UNITED STATES PATENT AND TRADEMARK OFFICE

APPLICATION NO.	FILING DATE	FIRST NAMED INVENTOR	ATTORNEY DOCKET NO.	CONFIRMATION NO.
10/724,966	12/01/2003	Lee J. Brown	1612	3032
20676	7590	01/09/2008		
ALFRED J MANGELS 4729 CORNELL ROAD CINCINNATI, OH 452412433			EXAMINER LAUX, JESSICA L	
			ART UNIT 3635	PAPER NUMBER
			MAIL DATE 01/09/2008	DELIVERY MODE PAPER

Office Action Summary

DETAILED ACTION

Claim 1: Sasamoto discloses a support bracket (FIG. 1a) comprising:

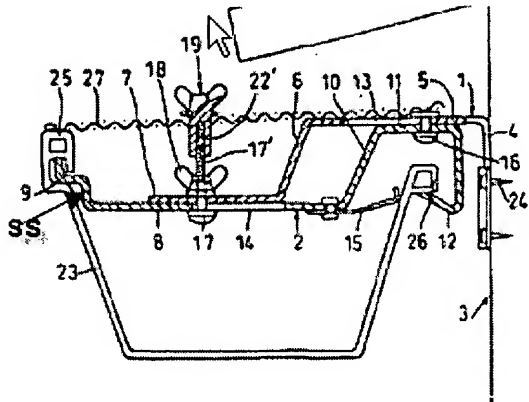
a unitary (in that it is a unitary device) substantially L-shaped body including a first leg (the portions 6, 5, 4, 10, 11, 12) that extends vertically, and a second leg (portions 7, 8, 9) that extends horizontally when installed, the first leg including a mounting surface (12) adapted to contact a rear wall of the gutter and a front surface (10) spaced from the mounting surface and connected therewith by a central panel (11) that extends in a longitudinal direction (where 11 extends in the same longitudinal direction of element 10 of the first leg) of the first leg and interconnects the mounting surface and the front surface (FIG. 1), the second leg including a support surface (shown as element ss in the annotated figure below) spaced from the mounting surface for supporting a front edge of the overlying gutter cover panel;

at least one first bore (apertures that receive fasteners 24) for securing the bracket to a building surface;

at least one second bore for receiving a cover fastener (aperture hole 14 for example, FIG. 1, 2a, are for connecting a cover panel 27 to the bracket, where hole 14 is in the front portion of the cover, thus meeting the functional limitation of the claimed bore);

engagement means (portion 9) carried by the second leg for engaging and supporting a front wall of the gutter (FIG. 1); and

upwardly-facing flat support surface means (6, 5) for engaging and supporting a rear surface portion of the gutter cover panel.

Claim 2: The Sasamoto first leg includes at least two bores spaced from each other along the first leg (two fasteners 24 are extended through two bores in portion 4; FIG. 1).

Claim 4: The Sasamoto engagement means (portion 9) is a hook member adapted to engage a reentrant lip of a gutter.

Claim 5: The Sasamoto support means (portion 6) is inclined in a downward direction from a plane defined by the mounting surface and extending toward the engagement means.

Claim 8: The Sasamoto second leg carrying a stop surface (the end of element 20, FIG 1) for abutment with and positioning relative to the bracket of a front edge of a gutter cover panel.

Claim 10: The Sasamoto body including at least one aperture (generally indicated at 16) for receiving a fastener.

Claim 11: The Sasamoto at least one aperture is positioned in the first leg (FIG 1).
